# ADDENDUM No. 1

## RFP No. 23-21

### FEASIBILITY ANALYSIS OF SELECT STORMWATER PROJECTS

**Location:**  
 Lawton Park  
**Identified Need:**  
 Flood mitigation; water quality improvements

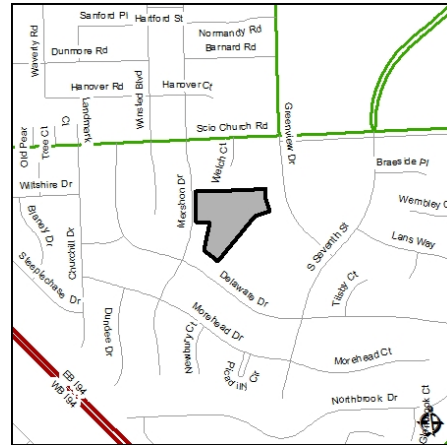
Question 9: **Please clarify which of the projects from the CIP are to be analyzed:**

Please note – the project listed in the RFP as “Lawton Park Stormwater Basin” is a part of the “Churchill Downs” suite of recommendations in the SWMM Report.

Answer 9: Please see attached project sheets for each project, from the City's CIP.

- Project Description:**
- Coordinate with Parks & Rec, AAPS, WCWRC;
  - Pipe improvement at 7th and Malletts Creek crossing;
  - Reroute storm sewer in Winsted, Mershon, Scio Church
